Ministerial Planning Referral: TPM-2020-18
582-590, 592, 594-598, 600-608 Elizabeth Street and 277-283 Queensberry Street, Melbourne

2 March 2021

MINISTERIAL PLANNING REFERRAL

Figures 19 & 20: Elizabeth Street (west) Elevation – Application Plans (left) Discussion Plans (right)

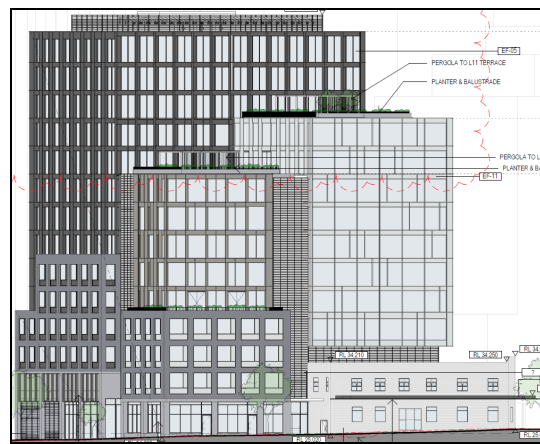
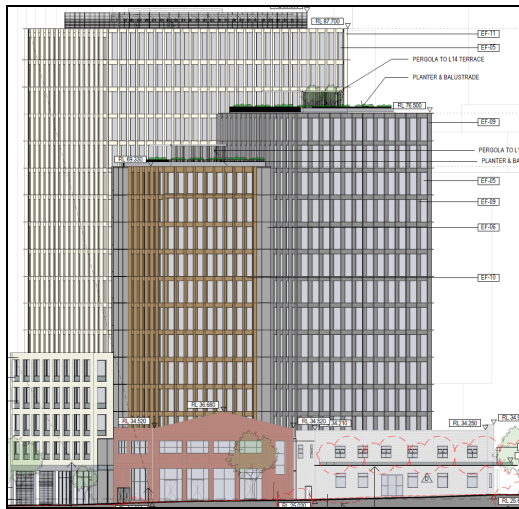
- The revised approach more closely resembles a patchwork of different façade expressions with no clear sense of visual cohesion between the lower and upper components.*

While it is important to introduce a contrasting design response to the street wall and upper levels, the above Urban Design comments are generally accepted in that the discussion plans have resulted in a loss of cohesion between building forms. The original plans resulted in a more unified response, which is demonstrated in Figures 19–24 of this report.

Figures 21 & 22: Queensberry Street (north) Elevation – Application Plans (left) Discussion Plans (right)

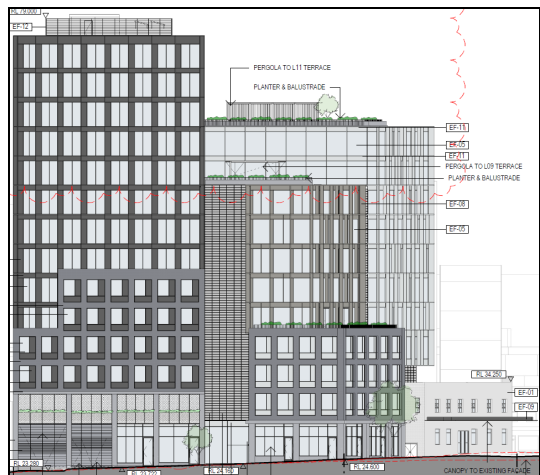
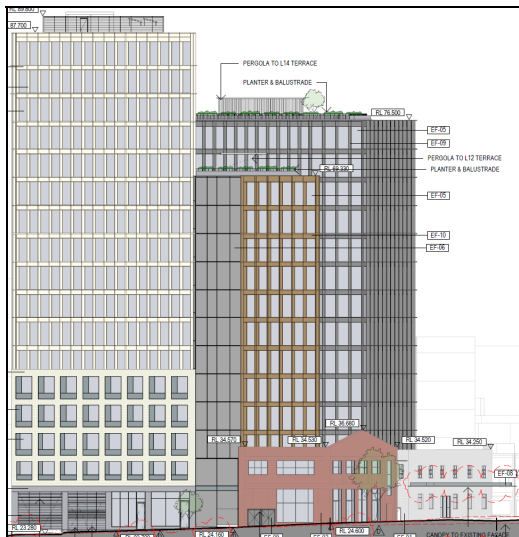
- *A greater setback would be required to ensure the predominance of the corner street wall, and to allow for adequate separation from an upper form. We defer to Council's Heritage Advisor and Planning for further commentary on setbacks above the retained heritage façade and street wall.*
